SERVICE BULLETIN

EQUIPMENT: WH-10

BULLETIN NUMBER: WSB WH-10-1 Revision A

To correct thumb wheel assembly clearance problem which causes the thumb wheel to stick.

Figure 1

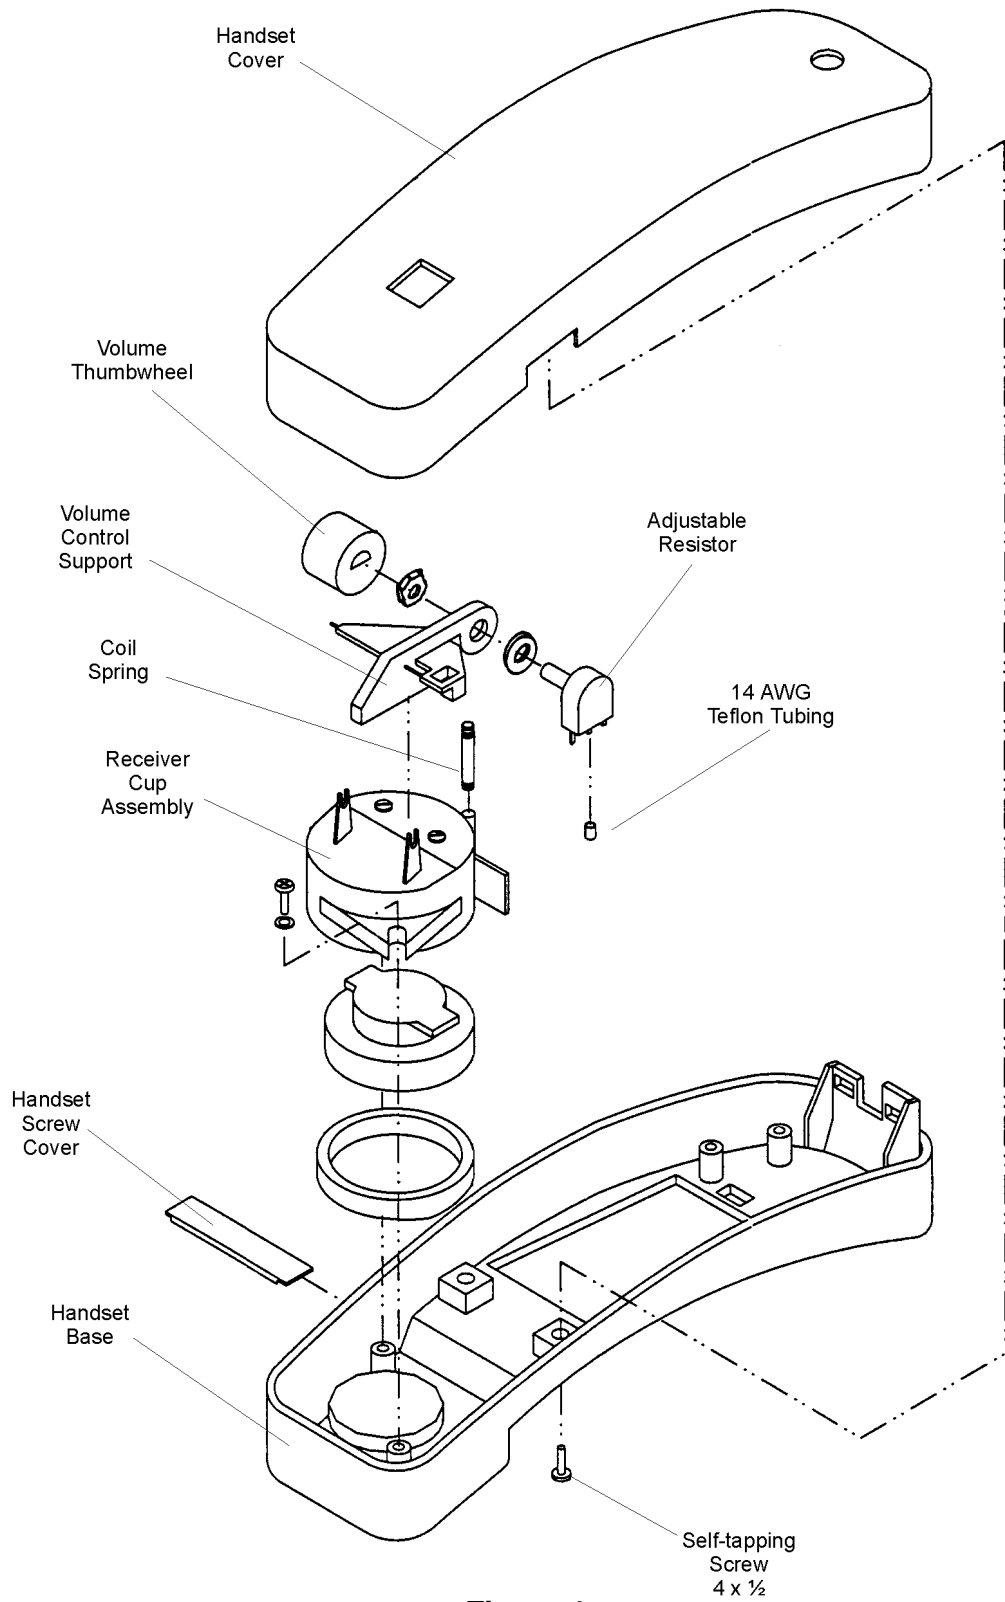
1. Remove the Handset Screw Cover from the Handset Base.
2. Remove the two 4 x 1/2 self-tapping screws that secure the Handset Cover to the base. Remove the Handset Cover.
3. Unsnap the Volume Control Support/Volume Thumbwheel/Adjustable Resistor assembly from the Receiver Cup Assembly.
4. Unsolder the three lead wires from the Adjustable Resistor. Discard the original Control Support/Volume Thumbwheel/Adjustable Resistor assembly.

3. Mount the Modified Adjustable Resistor on the Modified Volume Control Support P/N 246-0045-001 as shown in Figure 1. Use the nut and washer supplied with the resistor. Apply purple Loctite to the threads before installing the nut.

5. Snap the Volume Control Support/Volume Thumbwheel/Adjustable Resistor assembly into the posts on the Receiver Cup Assembly. Ensure that the locator on the bottom of the Volume Control Support fits into the top of the Coil Spring.

Figure 2

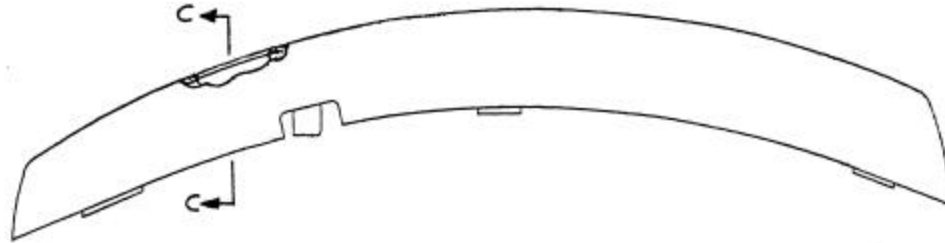
Modify the Handset Cover by removing the rib flush with the inside of the cover as shown in Figure 2.
